CitiPower 2026 - 2031 Regulatory Proposal

REVIEW OF ASPECTS OF PROPOSED EXPENDITURE ON REPEX, AUGEX AND VEGETATION MANAGEMENT

Report prepared for:
AUSTRALIAN ENERGY
REGULATOR (AER)
August 2025

Figure 3.6: Trend of defects and failures for poles

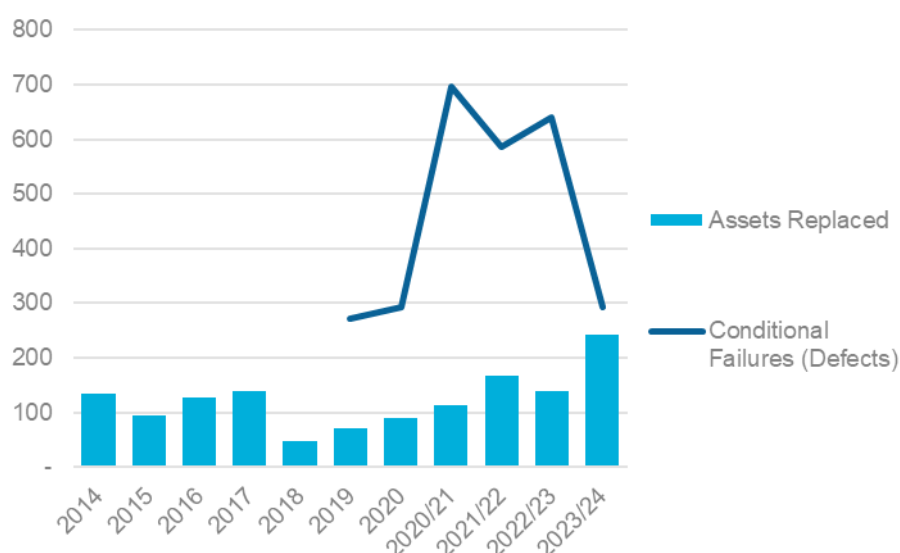
195. CitiPower claim that its pole failures are the highest or second highest in Victoria since 2019 and defects are increasing. We reviewed the data provided by CitiPower shown in Figure 3.6 which indicates a declining trend in defects with a similar downward trend in unassisted failures since 2021.

Figure 3.11: Trend of defects and failures for crossarms

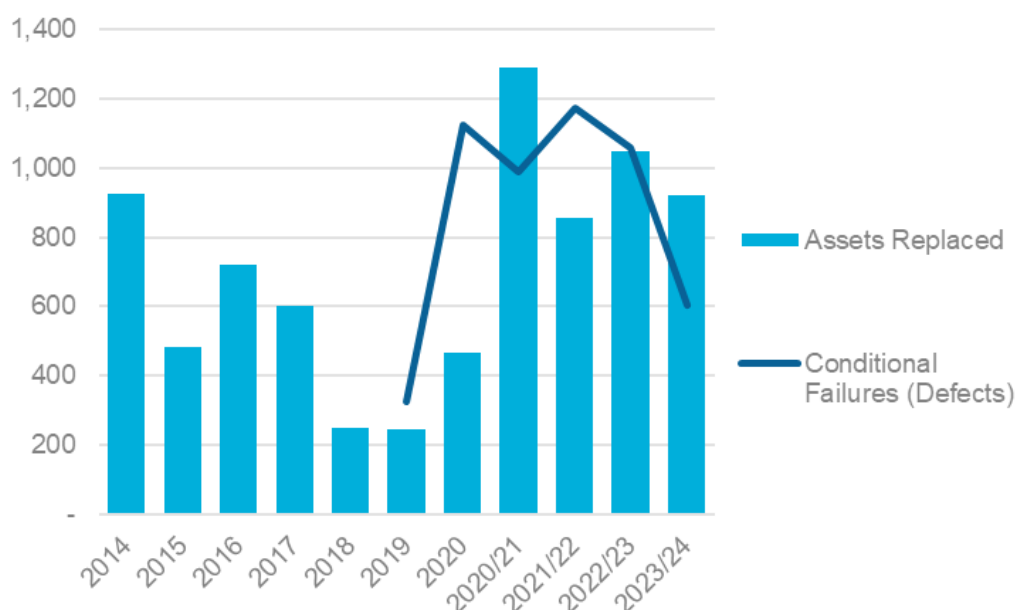
222. The defects and failure information provided by CitiPower indicates a declining trend in defects since 2021/22, which coincides with the increased volume of crossarm replacements. We show the declining defects in Figure 3.11. The data for unassisted failures is limited to the last 5 years and shows a slightly increasing trend.

223. Absent another explanation, a declining number of defects would be expected to result in a reduction to the number of crossarms being replaced in its crossarm replacement program. Moreover, whilst the data in Figure 3.11 includes total crossarm replacements (including pole replacements) the forecasting method applied to the crossarm replacement program does not take account of the increases to the pole replacement forecast.

Figure 3.20: Comparison of current and future protection relay HI values

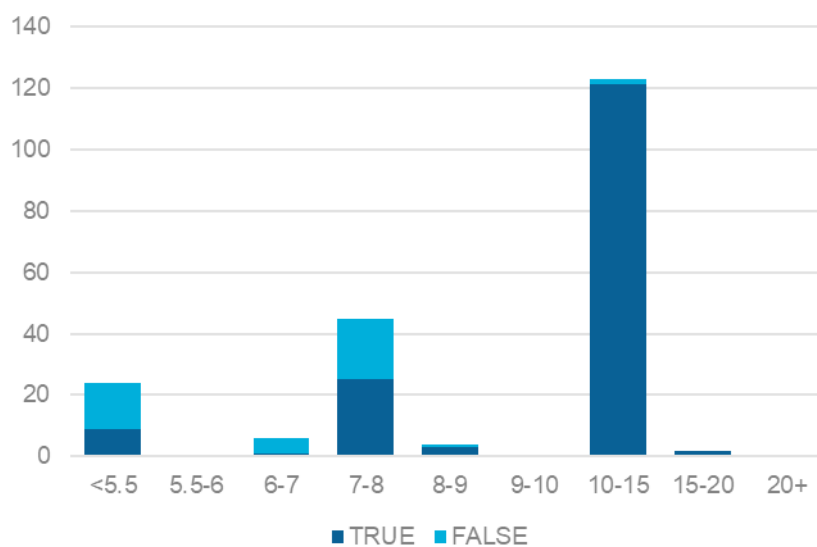
347. We observe a reasonable level of correlation between HI and relays selected by replacement. When we compare the current and future HI values determined from its CBRM models, we observe that there is significant increase in HI over this period as shown in Figure 3.20, with the largest population of relays in the HI range of 10-15, and a proportion of these not targeted for replacement. Similarly, there is a proportion of relays identified with a low (healthy) HI that is targeted for replacement.

348. There may be valid reasons for these decisions, however CitiPower does not explain the relationship between HI values and replacement decisions in the proposed projects. In the main, relays with a high HI are targeted.

Figure 4.4: CitiPower's maximum demand forecast vs capacity for B

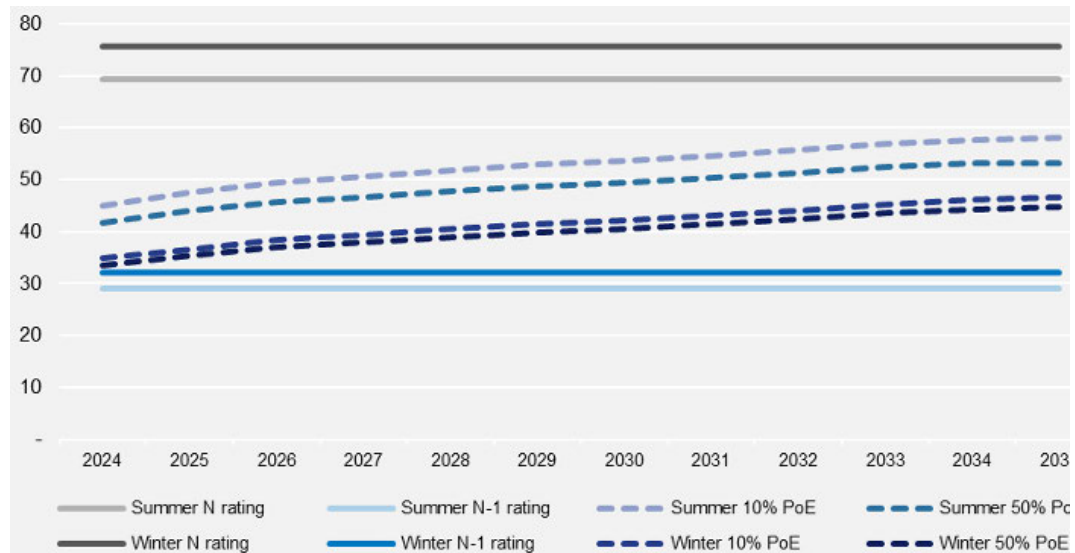
- The 10PoE maximum demand on North Richmond (NR) is forecast to exceed its firm capacity in FY31.⁸³
411. Figure 4.4 from CitiPower's business case shows the maximum demand exceeding the summer and winter N-1 capacity since 2024. If the firm capacity was modelled at 40.9MVA,

this would reduce the energy at risk materially, noting that it takes time to undertake the switching necessary to enact distribution transfer post an N-1 event, so the energy at risk derivation would need to take this into account.

Figure 4.5: CitiPower's maximum demand forecast vs capacity for VM

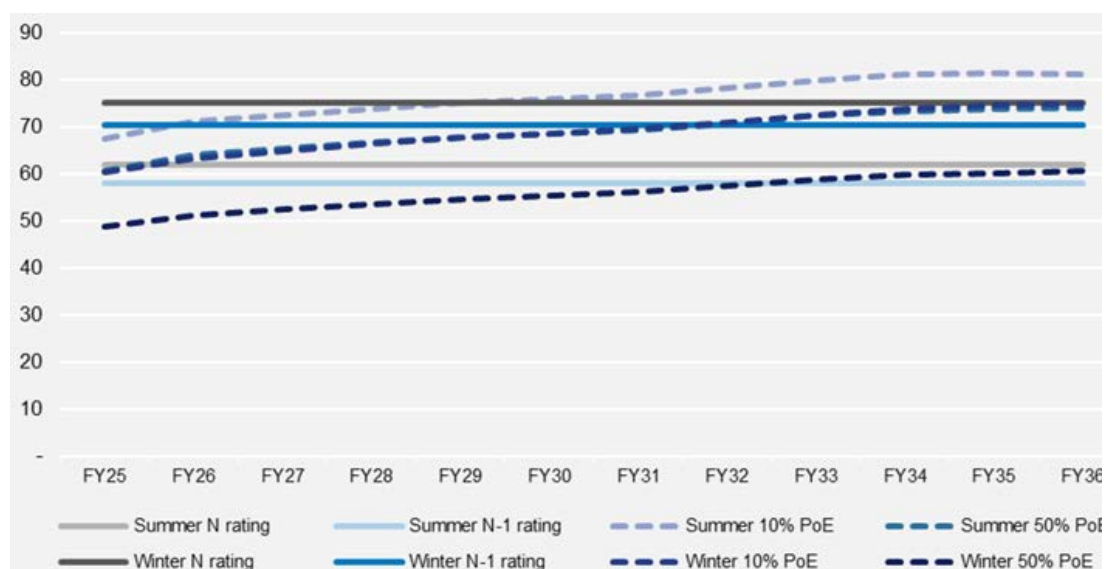
424. As shown in Figure 4.5, the N-1 capacity of 57.9MVA (summer) for VM is forecast to be exceeded in the summer of FY26 or FY27. The 57.9MVA rating is 3.9MVA above the combined nameplate rating of two of the three transformers, which indicates a relatively modest cyclic rating has been applied. This may be due to a relatively high loading factor for the substation but it is not adequately explained. Based on the cyclic rating of 34.4MVA for the B transformers discussed above, we would expect the firm capacity to be 68.8MVA plus an allowance for DTC.

Figure 5.1: Historical and forecast expenditure - \$m FY2026

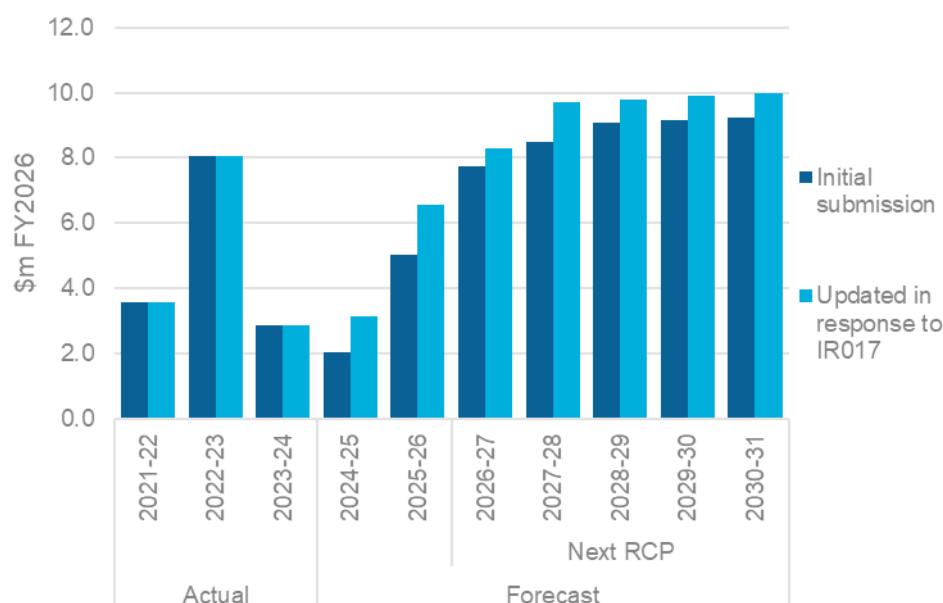
570. We show CitiPower's base program in Figure 5.1. CitiPower did not explain why expenditure in FY23 was much higher than the surrounding years, and which does not align with the profile of vegetation cuts.

Figure 5.3: Historical and forecast vegetation management spans that are required to be cut

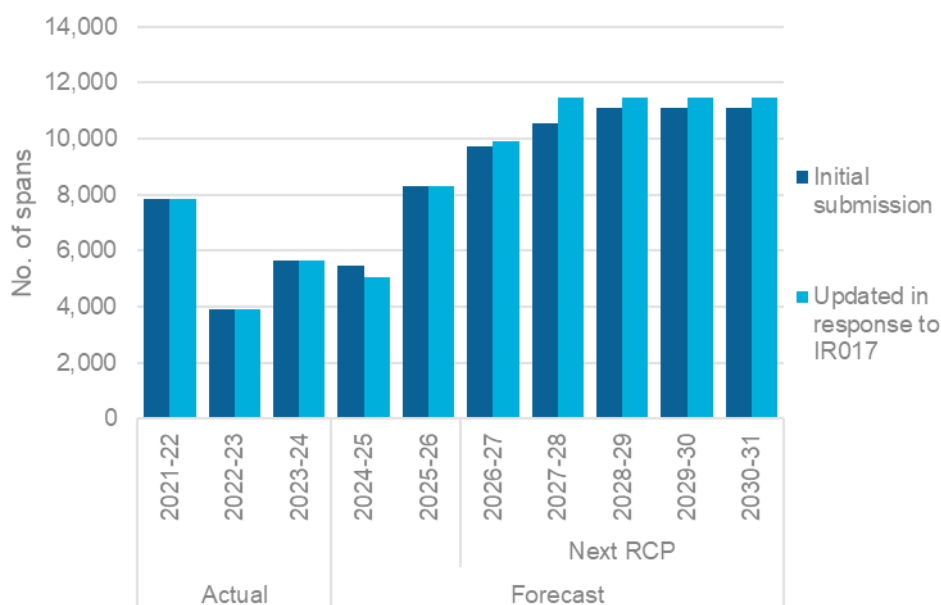
576. In Figure 5.3 we show the trend in volumes. We had expected to see a similar profile on the basis that the cutting volumes are a large driver of the costs. However, we observe a higher increase in volumes in IR017 than has been included in the initial submission, and a slightly lower starting volume in FY25.

Figure 5.6: VPN cutting status as at March 2025

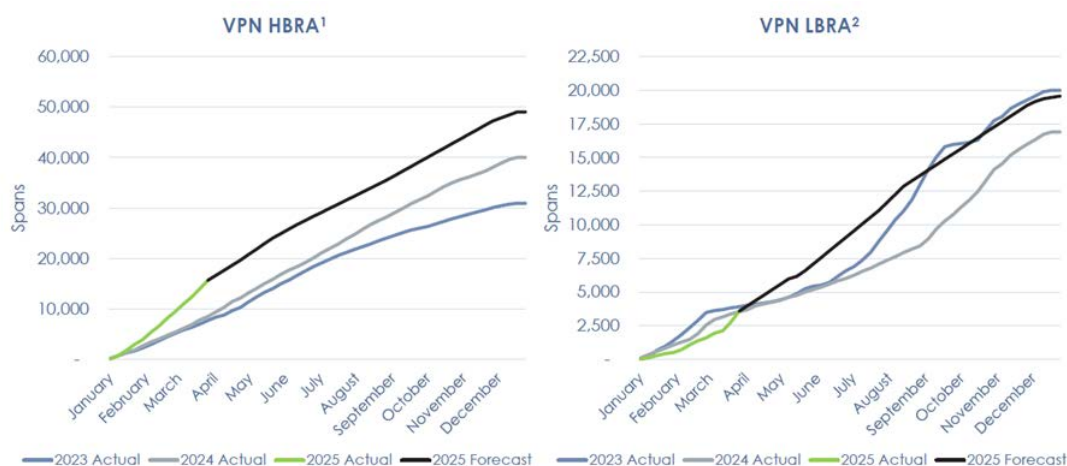
586. We consider that CitiPower's estimated cutting volume should be based on its latest forecast completion rates in 2024-25. From information provided by CPU, we consider that the forecast completion rates in 2024-25 are likely higher than has been estimated by CitiPower. In Figure 5.6 we show the forecast completion for LBRA, which is approximately 19,000 spans for 2025. If we approximate the completion rates across the 2024-25 year and remove approximately 12,000 spans for the 2024-25 year as reported by Powercor, a balance of 5,500 spans would result.

587. We therefore consider a more reasonable estimate for CitiPower in FY25 is around 5,500 spans, which aligns with the initial submission and a year-on-year increasing trend in vegetation cutting for CitiPower.

Figure 5.7: Trend of average vegetation management unit rates - \$, FY2026

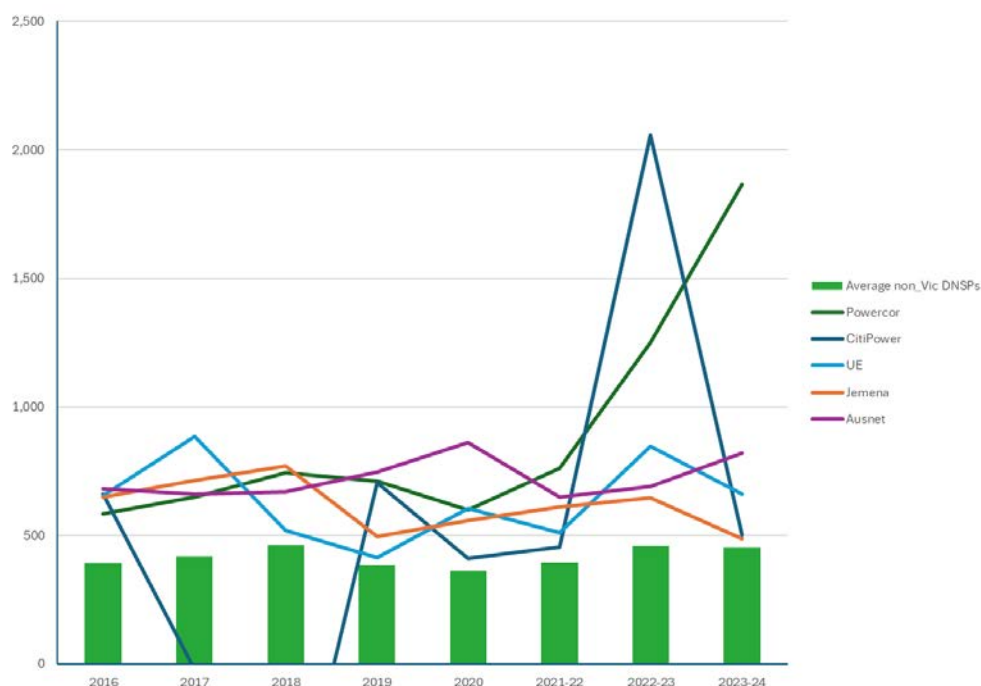
594. We considered unit rates over time as shown in Figure 5.7 and observe that the Victorian DNSP unit rates were largely flat in real terms, with the exception of Powercor and CitiPower, which both increased from 2021-22 with CitiPower subsequently reducing to previous levels in 2023-24. The negative amounts are not explained by CitiPower.

Figure 5.12: Proportion of LiDAR costs – Powercor and CitiPower, \$m FY2026

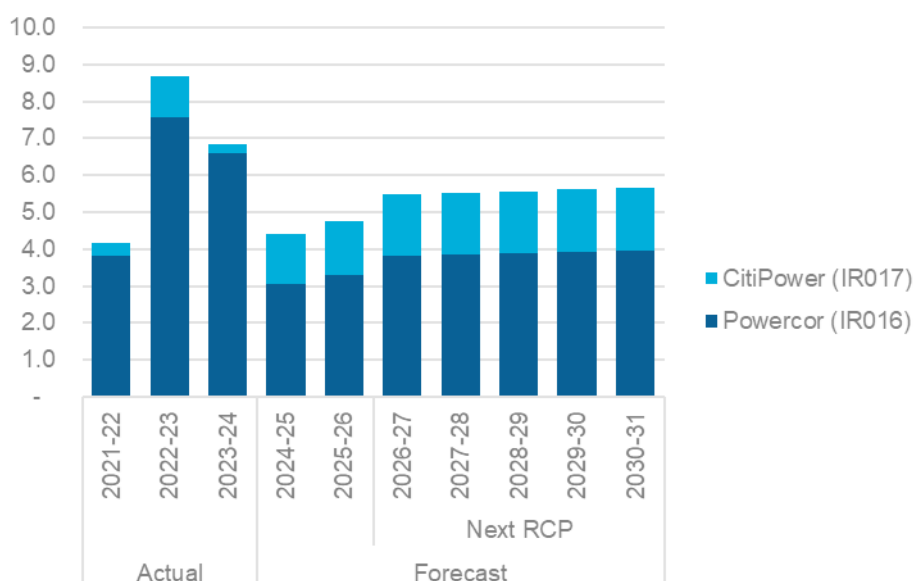
614. In Figure 5.12 we show the LiDAR costs over time for CitiPower and Powercor, and can see that the allocation has changed, and that the change was made in 2024-25 which CitiPower is claiming as its base year, and therefore is not a reason for an increase in the forecast.
